**Addendum / Addenda**

No./N<sup>o</sup>  
2

Project Description / Description de projet <b>M-7 Cooling Tower Replacement</b>		
Solicitation No./ No de sollicitation <b>13-22085</b>	Project No./N <sup>o</sup> de projet <b>3861</b>	W.O. No./N <sup>o</sup> d'ordre de travail <b>A1-004116-01-03-02</b>
Departmental Representative / représentant ministériel <b>Chris Day</b>		Date <b>Dec 5<sup>th</sup>, 2013</b>
<b>Notice:</b> This addendum shall form part of the tender documents and all conditions shall apply and be read in conjunction with the original plans and specifications.		<b>Nota:</b> Cet addenda fait partie intégrale des dossiers d'appel d'offres; toutes les conditions énoncées doivent être lues et appliquées en conjonction avec les plans et les devis originaux.

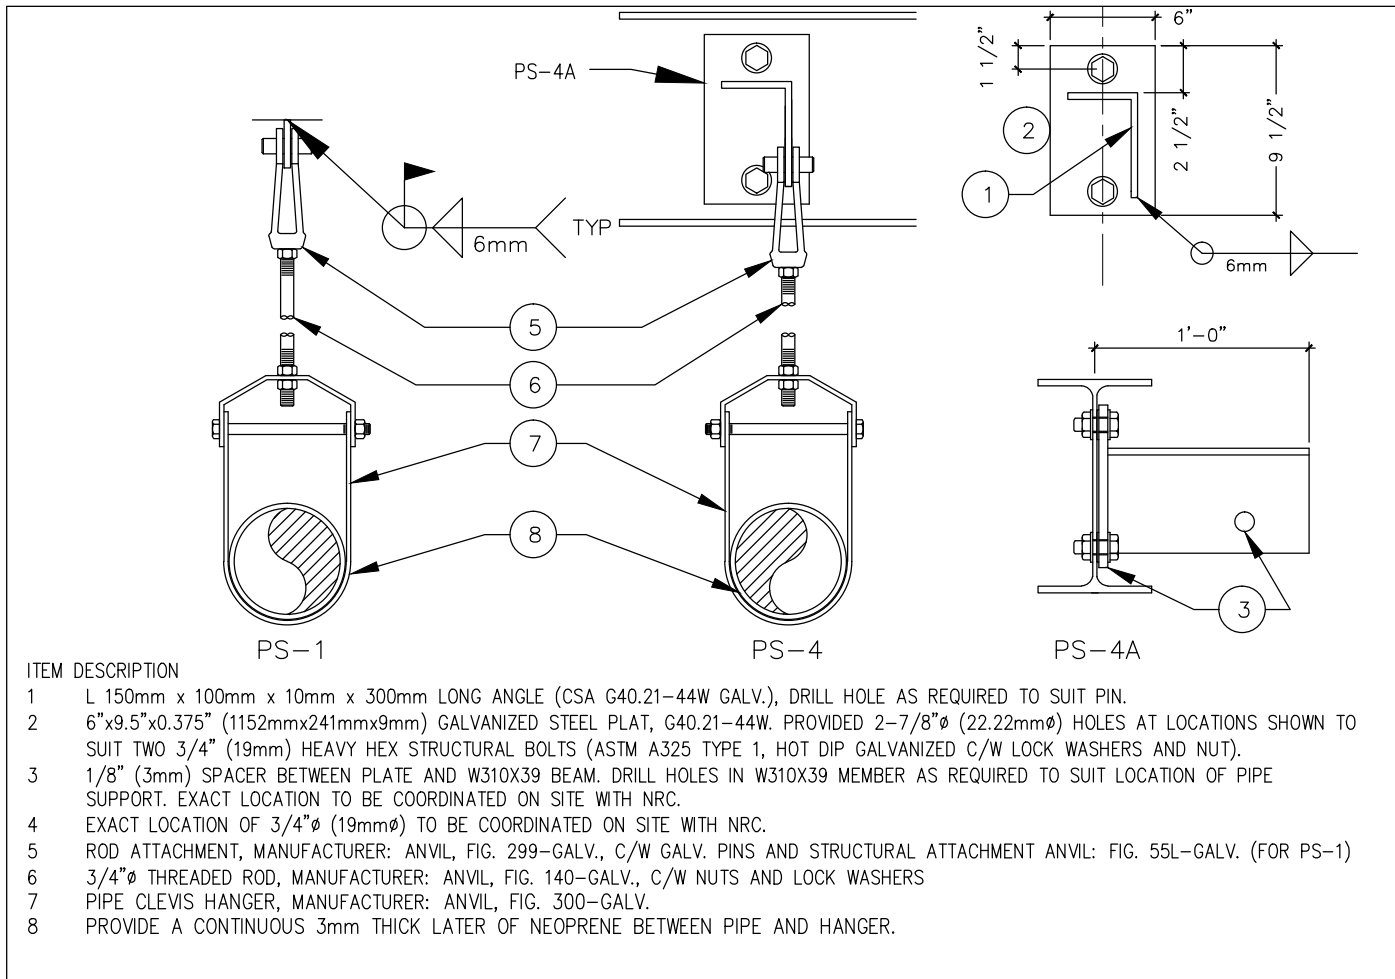
1. Delete Detail 4: Piping Support Detail (PS-2) on drawing "3861-M02" and replace with drawing "3861-ADD2-MSK-1"
2. Delete Detail 5: Piping Support Detail (PS-1 and 4) on drawing "3861-M02" and replace with drawing "3861-ADD2-MSK-2"
3. Cooling Tower Schedule

- 1 L 150mm x 100mm x 10mm x 300mm LONG ANGLE (CSA G40.21-44W GALV.), DRILL HOLE AS REQUIRED TO SUIT PIN.
- 2 6"x9.5"x0.375" (1152mmx241mmx9mm) GALVANIZED STEEL PLAT, G40.21-44W. PROVIDED 2-7/8"Ø (22.22mmØ) HOLES AT LOCATIONS SHOWN TO SUIT TWO 3/4" (19mm) HEAVY HEX STRUCTURAL BOLTS (ASTM A325 TYPE 1, HOT DIP GALVANIZED C/W LOCK WASHERS AND NUT).

- 3 1/8" (3mm) SPACER BETWEEN PLATE AND W310X39 BEAM. DRILL HOLES IN W310X39 MEMBER AS REQUIRED TO SUIT LOCATION OF PIPE SUPPORT. EXACT LOCATION TO BE COORDINATED ON SITE WITH NRC.

- 4 EXACT LOCATION OF 3/4"Ø (19mmØ) TO BE COORDINATED ON SITE WITH NRC.
- 5 ROD ATTACHMENT, MANUFACTURER: ANVIL, FIG. 299-GALV., C/W GALV. PINS AND STRUCTURAL ATTACHMENT ANVIL: FIG. 55L-GALV. (FOR PS-1)

- 6 3/4"Ø THREADED ROD, MANUFACTURER: ANVIL, FIG. 140-GALV., C/W NUTS AND LOCK WASHERS
- 7 PIPE CLEVIS HANGER, MANUFACTURER: ANVIL, FIG. 300-GALV.
- 8 PROVIDE A CONTINUOUS 3mm THICK LATER OF NEOPRENE BETWEEN PIPE AND HANGER.

Project no. 3861-S01 - Revised

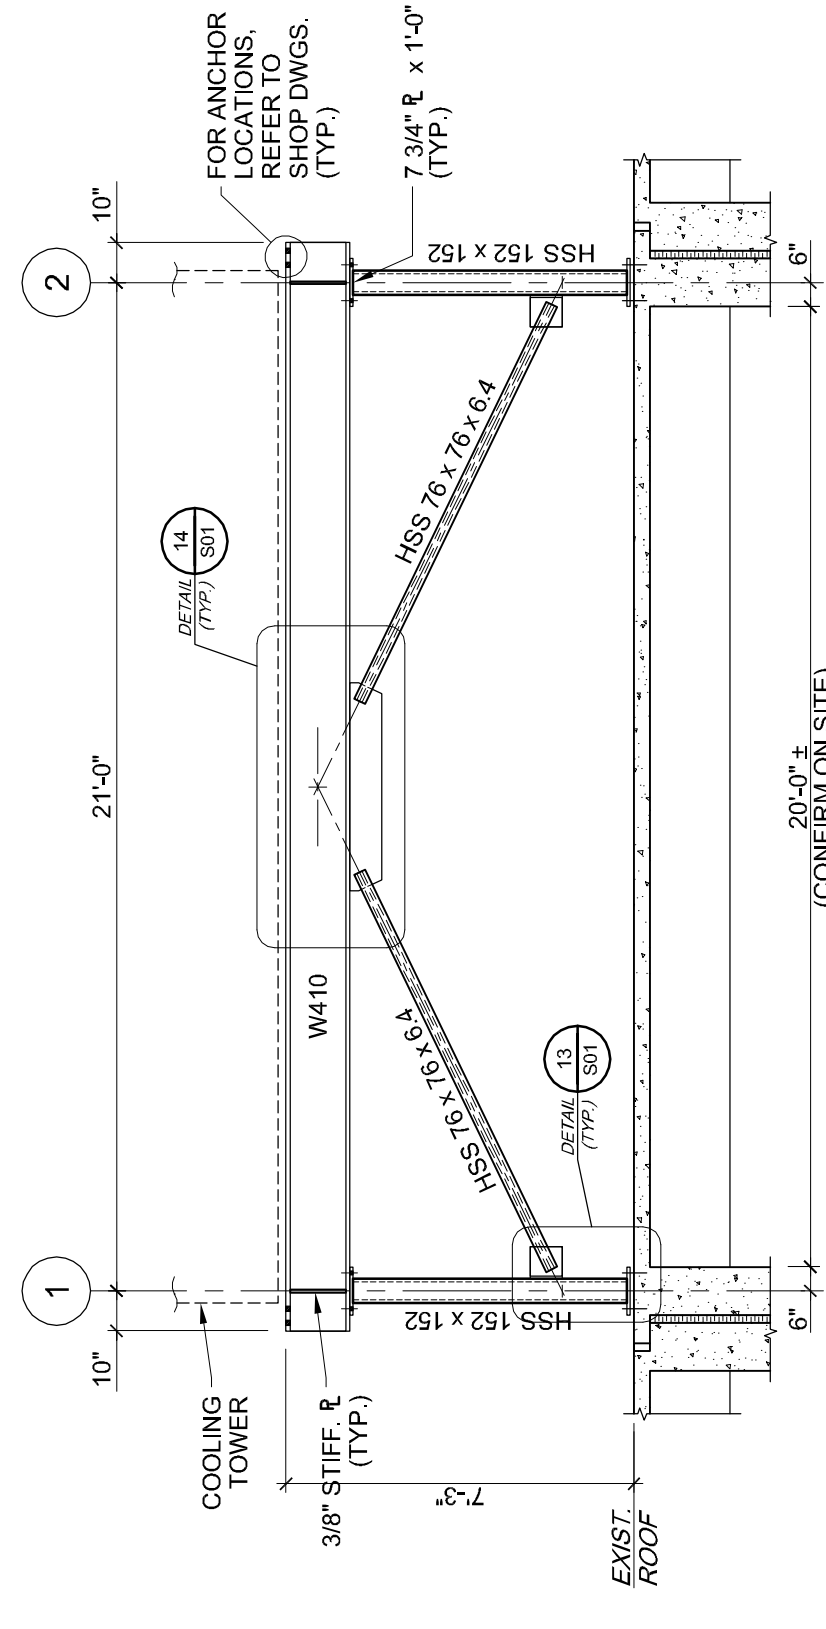
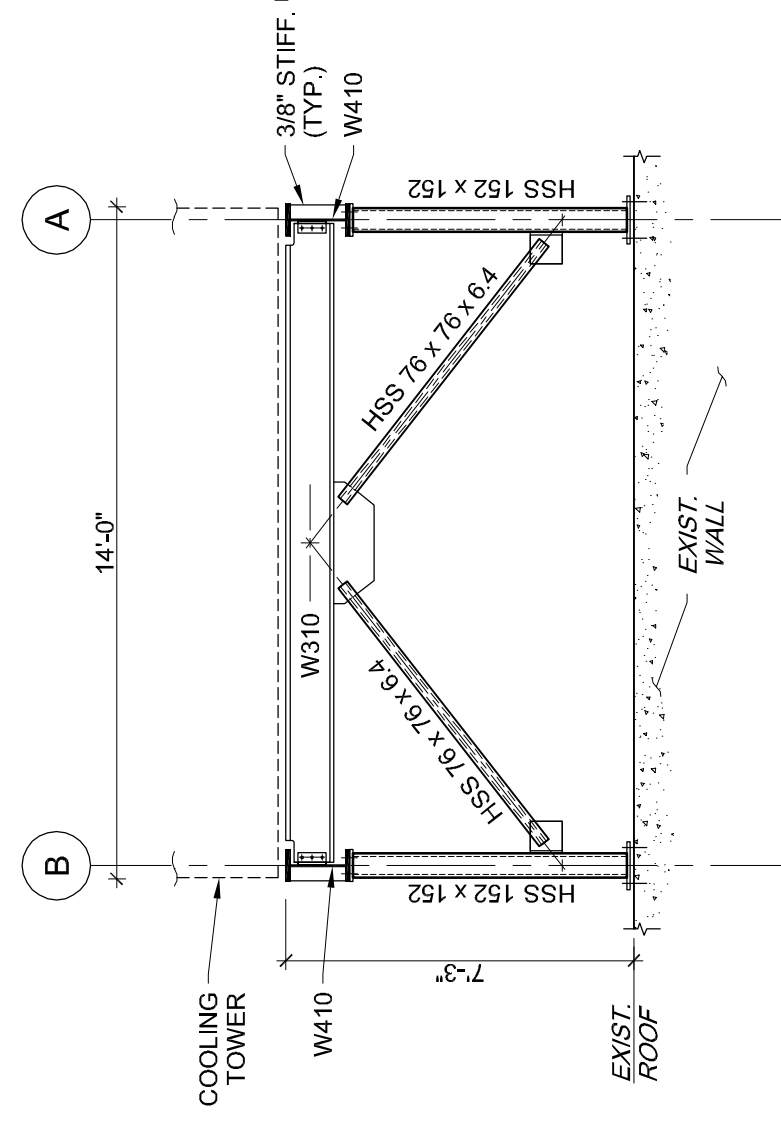
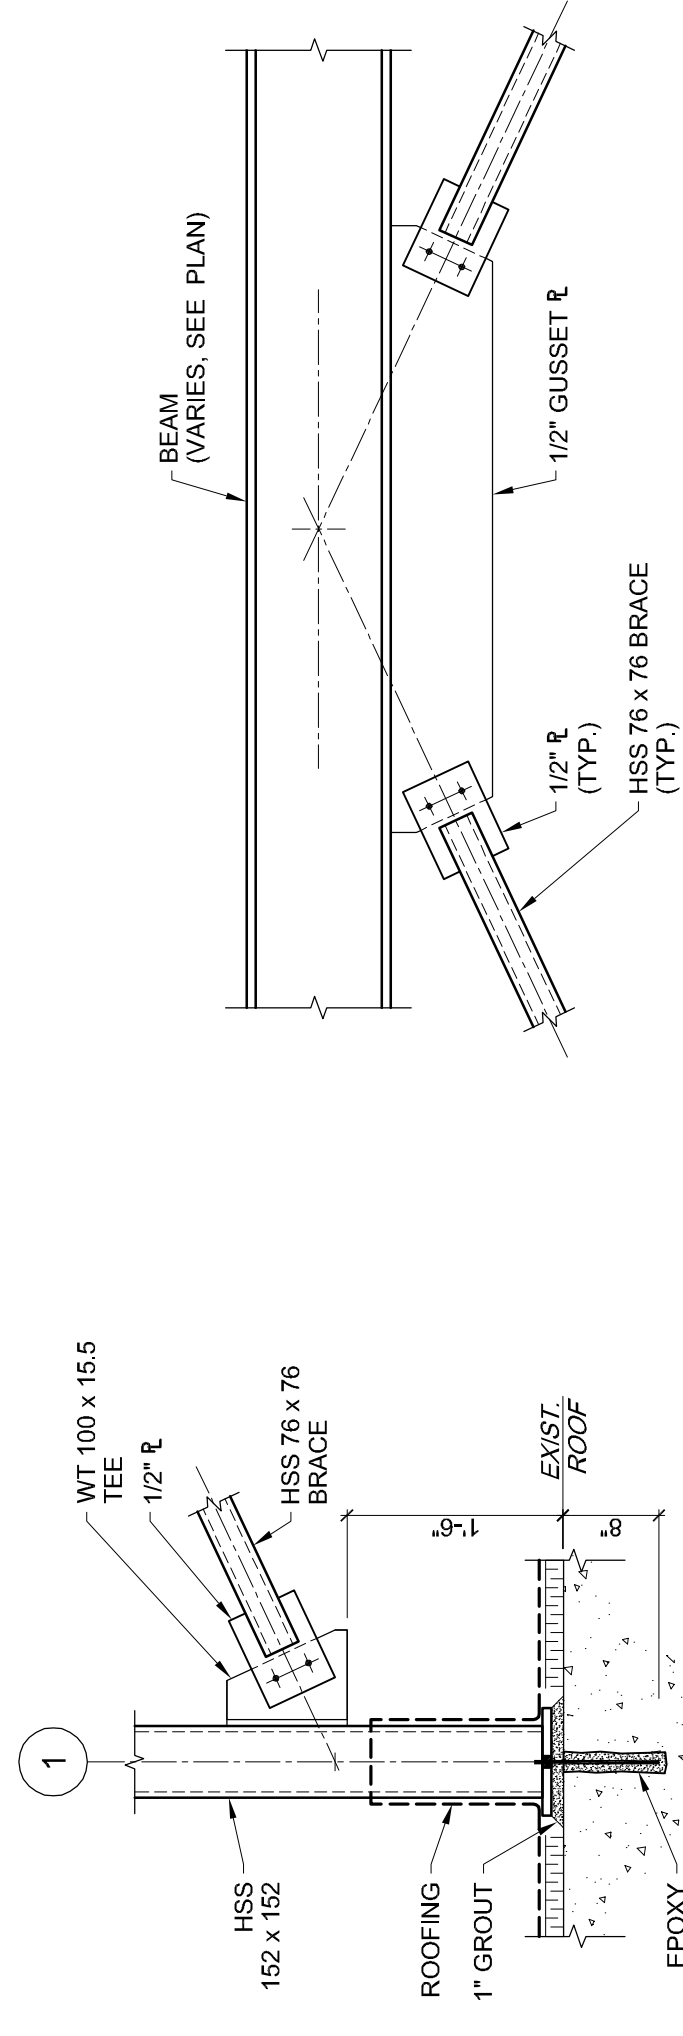
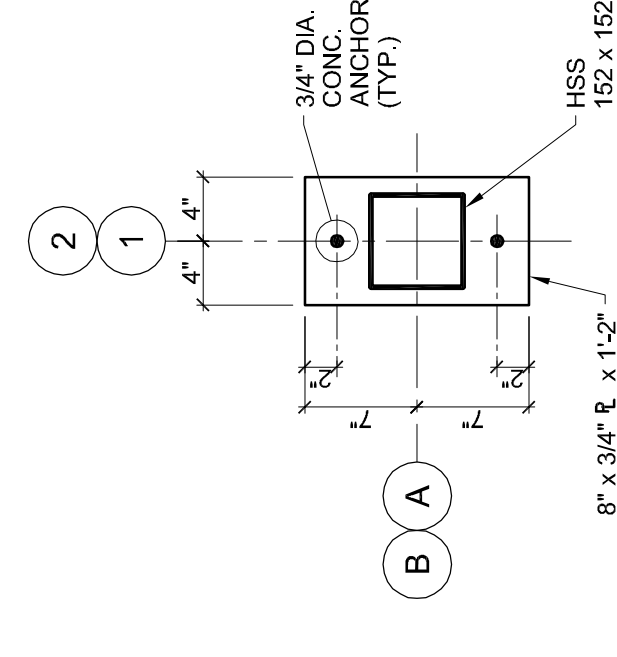
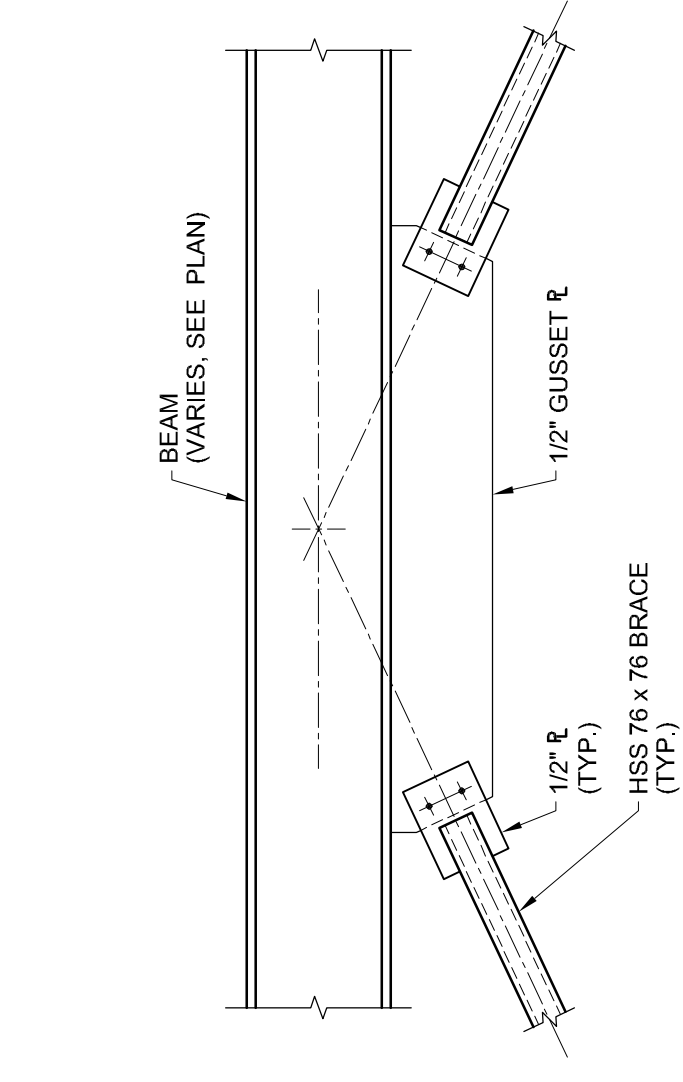
1. Delete drawing "3861-S02" and replace with drawing "3861-S01-Revised" included in Addendum 2.
